Trumbull County Board of Health – Special Meeting
August 9, 2021 – 6:00 PM
Hubbard City Council Chambers
220 W. Liberty St. * Hubbard, Ohio 44425

RE: Technical Review Comments for
Trans Rail America C&DD License Application
Hubbard Township, Trumbull County, Ohio

OAC & Technical Review Comments

TRANS RAIL AMERICA, INC.
 CONSTRUCTION AND DEMOLITION
 DERIS FACILITY
 GRADING
 BOTTOM OF DERIS

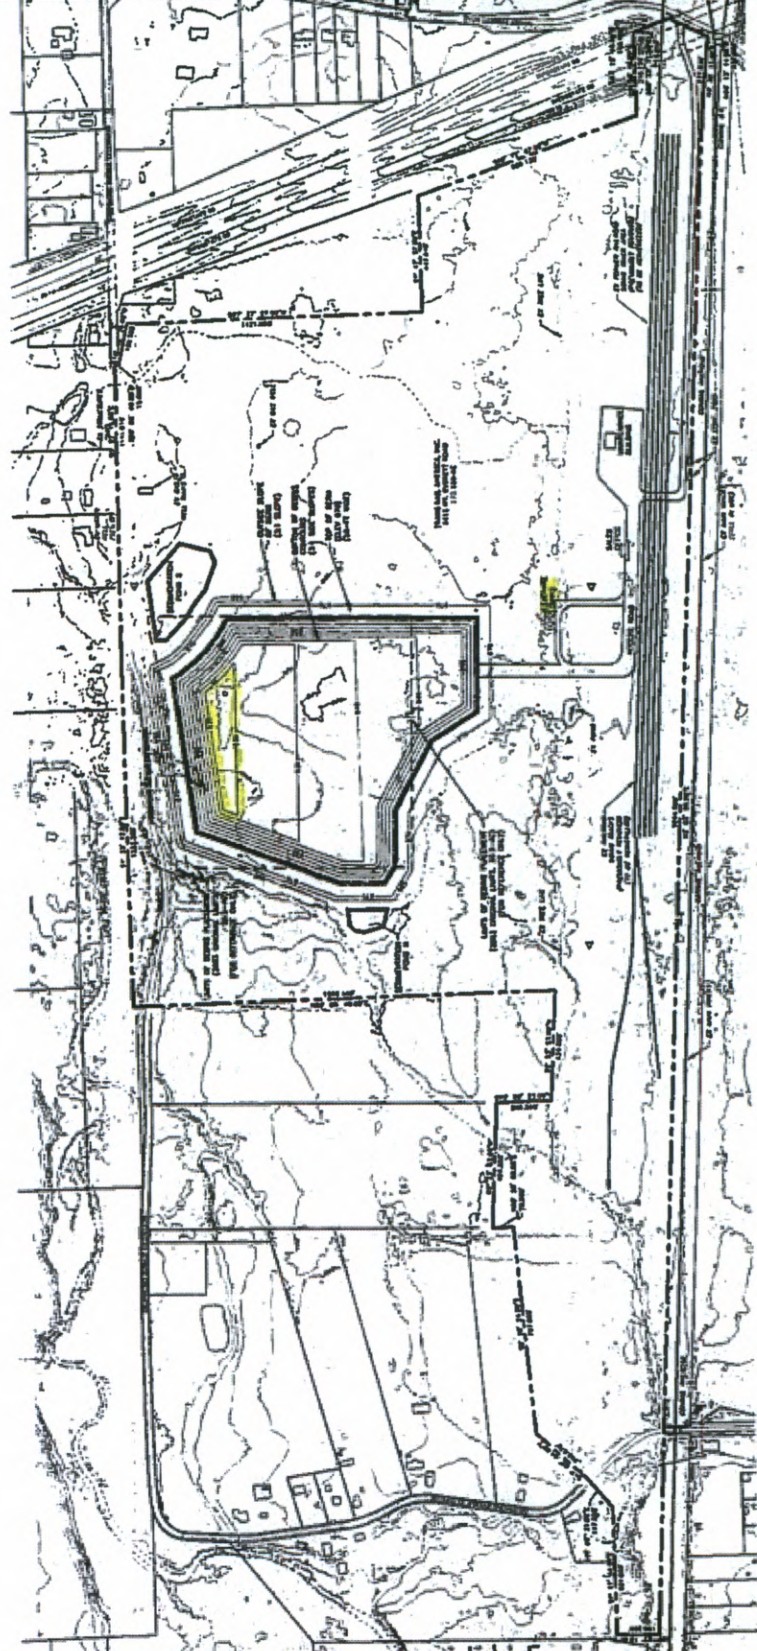
OAC 3745-400-07 (F)(5)(c)(ix) & (x) requires that the system be designed to be capable of conveying leachate outside the limits of the debris placement for treatment and discharge. Drawings from Buckeye shows leachate tanks west of the debris field. How the leachate is collected, routed and discharged from the eastern edge of the disposal field to the leachate tanks is not shown. A leachate collection sump, pump, force main, and sample port is not shown or detailed. Certified calculations are not provided from

Buckeye showing the estimated leachate volume, flow rate or sizing of the proposed tanks. The facility plan has no information regarding sampling, pretreatment, hauling or disposal of the leachate to an approved treatment facility. Furthermore, there appear to be drainage issues on the Bottom of Debris grading plan shown on Sheet 7c (Ref. attachment). The north/south slope between the 930 contour across the eastern floor of the disposal area appears less than the minimum slope of 2% which contradicts OAC 3745-400-07 (F)(5)(c)(iii)(a). No sufficient information was available demonstrating that the leachate will not accumulate beyond the one-foot minimum depth allowed on the bottom of the constructed liner" [OAC 3745-400-07(F)(5)(c)(ii)] or functioning without clogging [OAC 3745-400-07(F)(5)(c)(vi)]. Calculations and information demonstrating compliance with the leachate collection system elements outlines in OAC 3745-400-07(F)(5)(c) must be provided.
